Keystone RV Company

SAFETY ADVISORY #22-435

Dutchmen Stabilizer Jack Switch

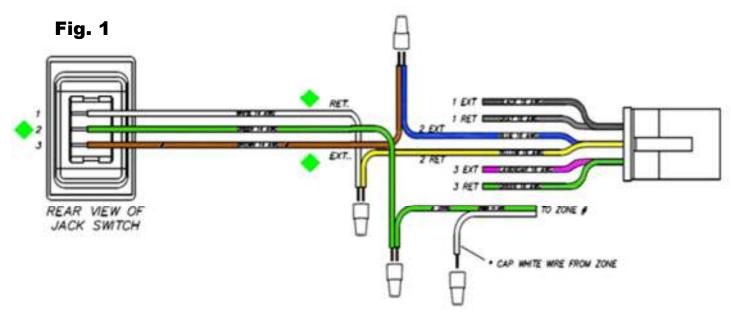
Keystone is conducting a voluntary RECALL notification campaign in accordance with the National Highway Transportation and Safety Act. It has been decided that the vehicles in the recall population have an electric stabilizer jack switch that is not waterproof from the back side of the switch. Under certain conditions during travel, the back side of the extend/retract switch for the electric stabilizer jacks can short out causing the jacks to extend during travel, leading to an increased risk of personal injury, and or vehicle crash.

The remedy is to replace the existing stabilizer jack switches with the waterproof switches, 2 – KRV # 700834 - Switch - 12V - Mom On/Off/Mom On - SPDT - 260F - IP66 - Gasket - w/Extended Retract Print - w/Wire Harness – Black.

Using the replacement stabilizer jack switches, KRV # 700834 - Switch - 12V - Mom On/Off/Mom On - SPDT - 260F - IP66 - Gasket - w/Extended Retract Print - w/Wire Harness — Black, match the wire colors using the diagram in Figure 1. Stabilizer Jack wiring to unit harness wiring - White to Yellow, Green to Green, and Brown to Blue. Any remaining harness wires should be capped off and not used.
